Memorandum

RE: Other Business for the December 10, 2020 Planning Commission Meeting

This memo is to provide background for the Planning Commission to consider as a part of the Other Business to be reviewed during the December 10, 2020 Planning Commission meeting.

Scale: 1" = 60' Dwn.By: JMJ, KJK Proj.No.: 0818C032

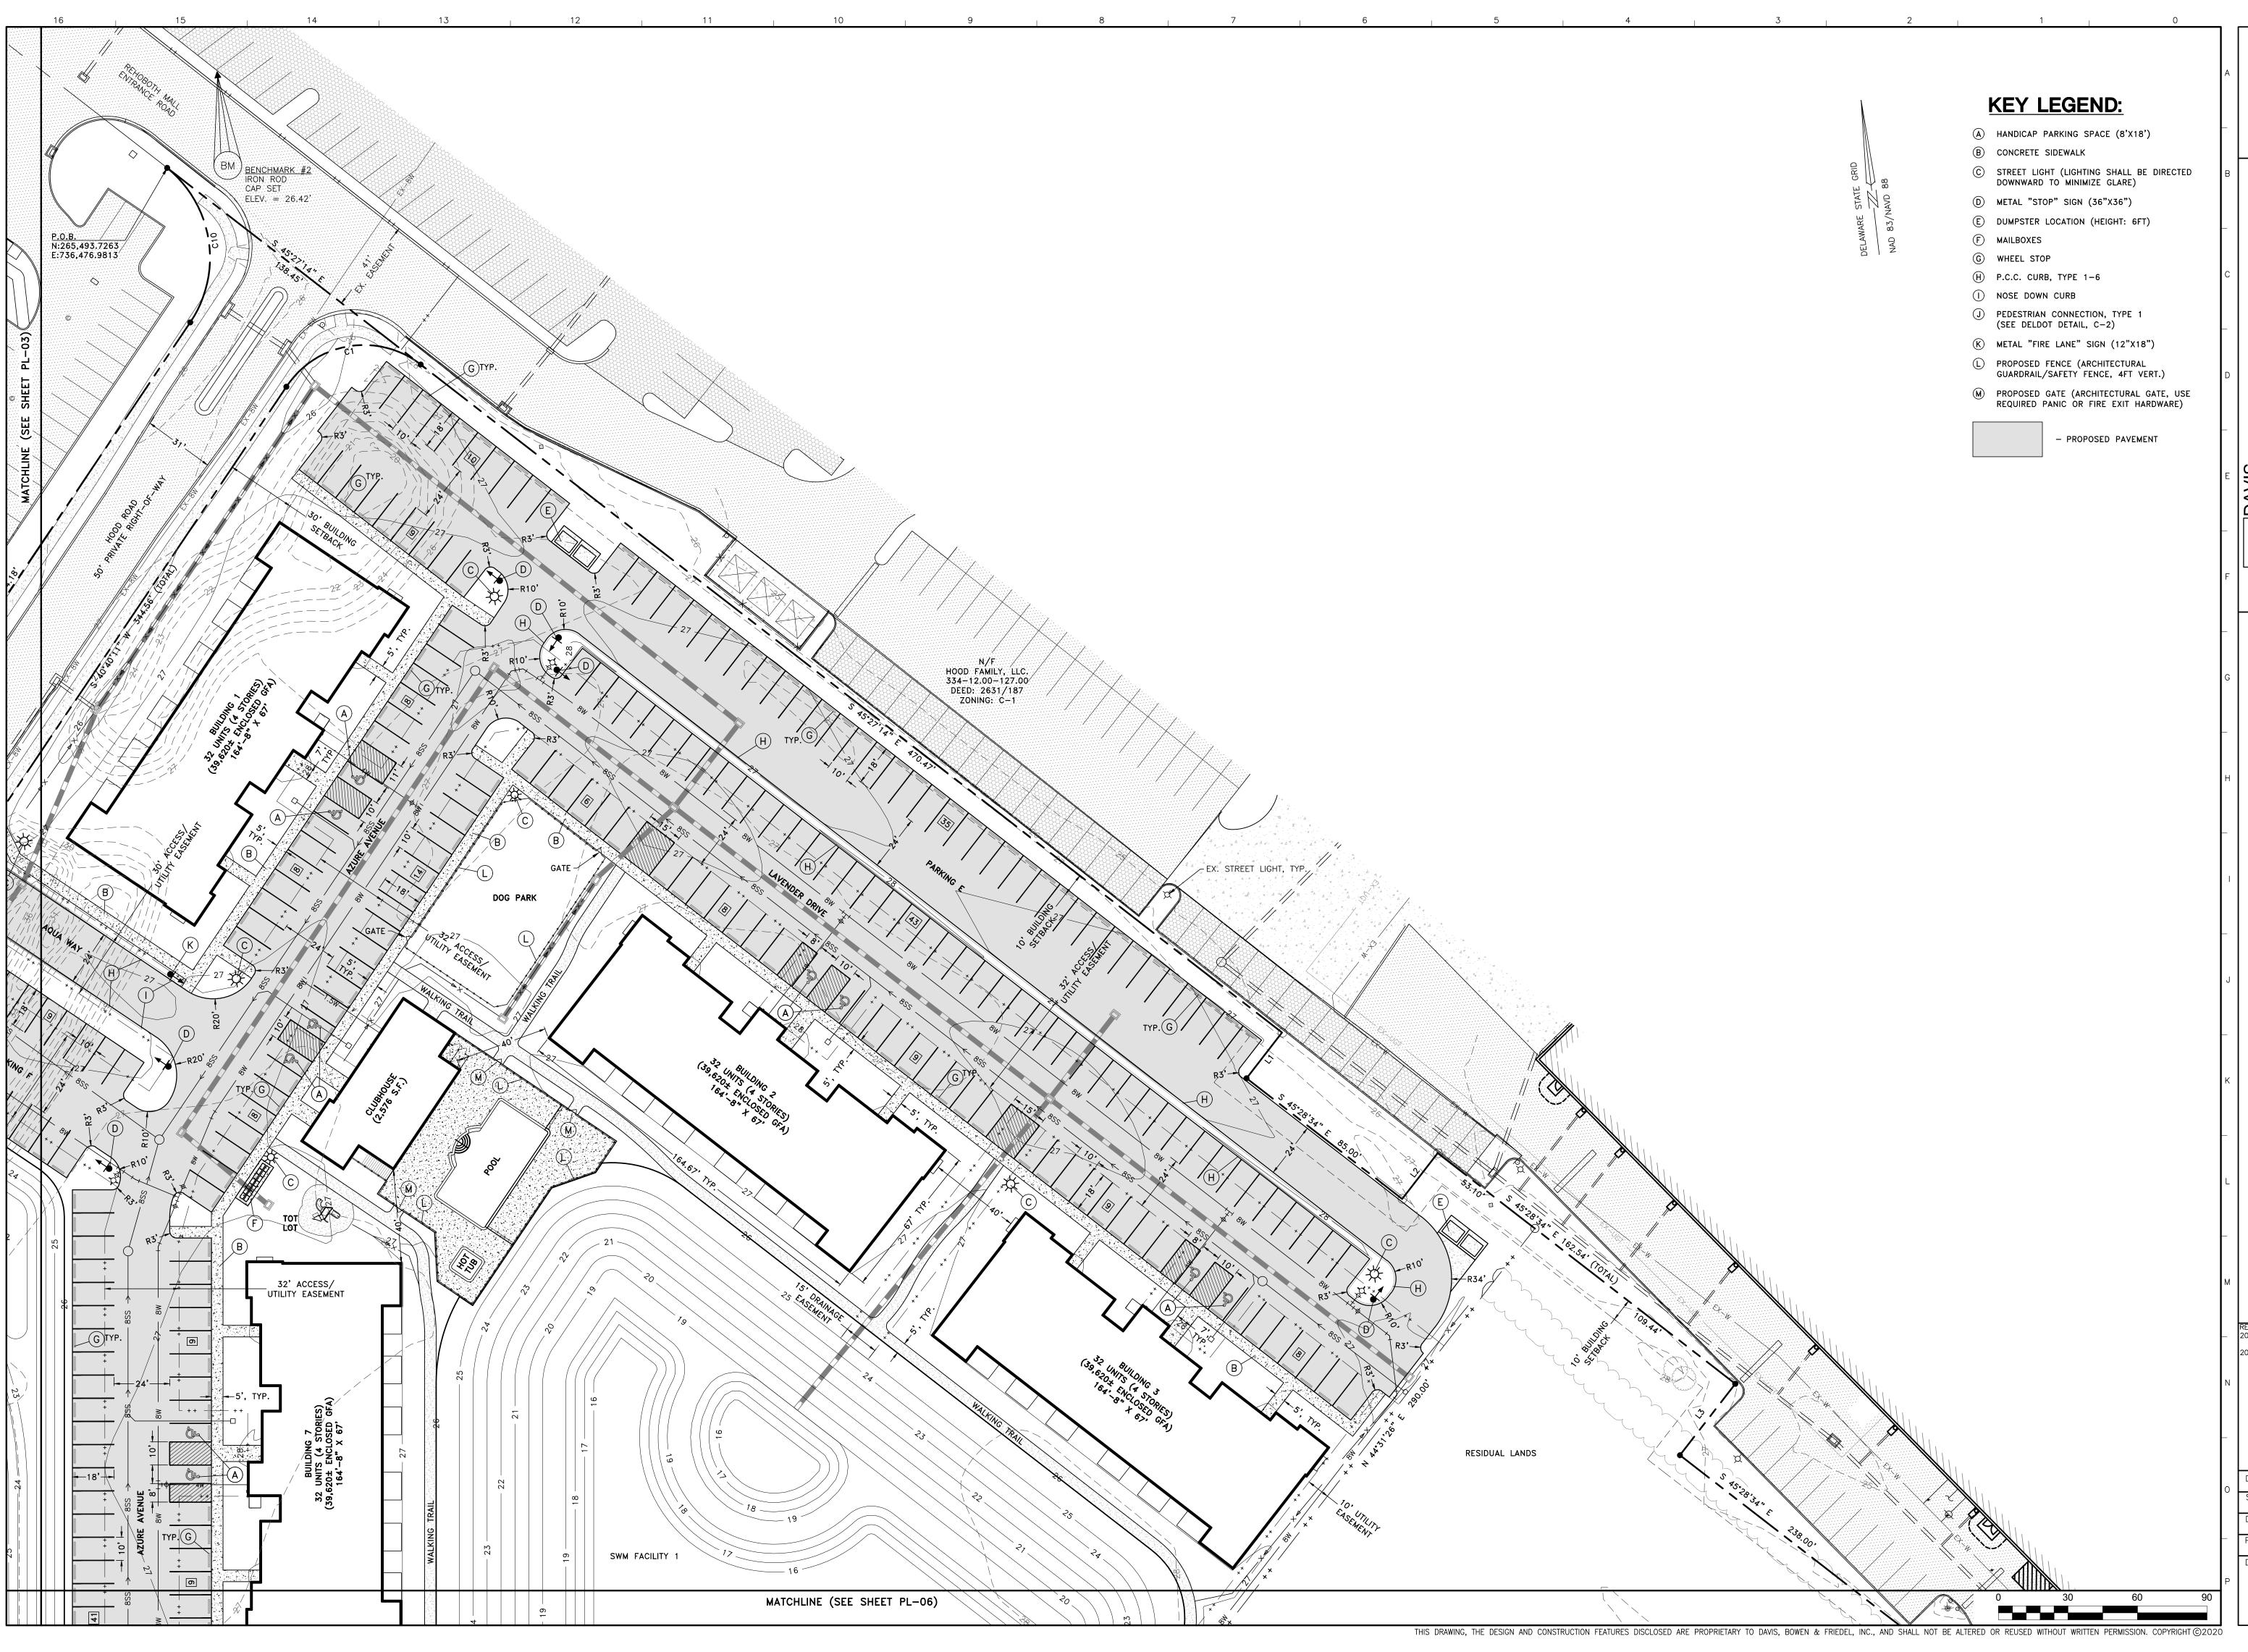
This is a Preliminary Site Plan for a proposed 224-unit multi-family apartment complex to consist of a clubhouse, pool, dog park, tot lot, 448 parking spaces and other site improvements located on 18.759 acres +/-. The property is located directly east of John J. Williams Hwy (Route 24) just south of Coastal Highway (Route 1). The applicant is seeking relief for 74 parking spaces to be located within the front setback of a private right of way. The Preliminary Site Plan otherwise complies with the Sussex County Zoning Code. Tax Parcel: 334-12.00-127.01 & 127.10. Zoning: CR-1 (Commercial Residential Zoning District). Staff are awaiting agency approvals.
